## Questions on the TEMA model

Input from ACEA, JAMA and AI member companies compiled by Annika Ahlberg Tidblad 2020-12-05.

**Documents reviewed:** EVE-22-07  
EVE-23-08  
EVE-24-10  
EVE-28-13  
EVE-30-12  
EVE-32-13  
EVE-33-07  
EVE-34-16  
EVE 36-09  
EVE-38-02

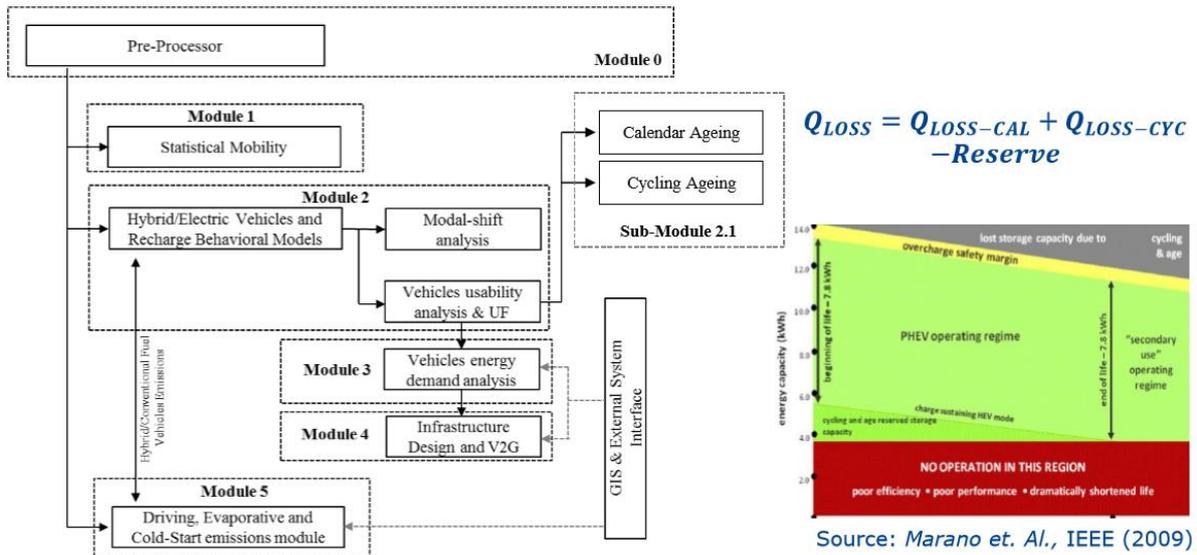
3. Life prediction estimates (year and milage) are outputs from Module 2. How does Module 4 feed back to module 2 for life estimations including e.g. V2G ageing?

4. Please explain the diagram on the right. What does it mean and what is the relevance for the model? 4 This was introduced in EVE 23-08 in relation to the capacity reserve and safety margins discussion at that time (i.e. the battery must not be overcharged...) and adding a reference about it. As per the assumptions reported, TEMA module is considering calendar and cycle ageing in an additive way, despite there are also mixed contributions or they can be reduced to the similar effects. Some literature works were referred in previous presentations and discussions about this aspect and we added also this reference in this slide set. The implemented parts are referred to open source information from literature if available. While developing the model we asked ourselves if considering calendar and cycling effect just additive was going to cause extra error, if making the assumptions reported was correct enough and we are still investigating this. We do not have our own data to refer to. So we looked for open source publications. A correction factor might be added if needed. The diagram was reported as reference for the discussion.

3 We have to update the flow chart adding a link from V2G to in-vehicle battery durability module, missing here above. V2G is a study we did years ago to study the grid optimisation and peak shaving and recently we went back to it while thinking that V2G should be considered in the in-vehicle battery ageing in view of a wide spread of future applications. It explores the possibility to have vehicles parked but not charging giving back to the grid part of the energy store in their battery. The first V2G ageing analysis was presented in Geneva, in one of the last face-to-face meeting. As presented different scenario where analysed with different share of energy, from little amount, 2% up to higher shares, always however checking that the vehicle that shares the energy to the grid can still perform the trip after the parking event. In this way the chain of driving and parking events is not broken. V2G is considered as an additional cycling of the battery with given power and the in-vehicle battery durability module has been modified to consider this extra cycling of the battery if it can be applied without breaking the driving-parking chain.
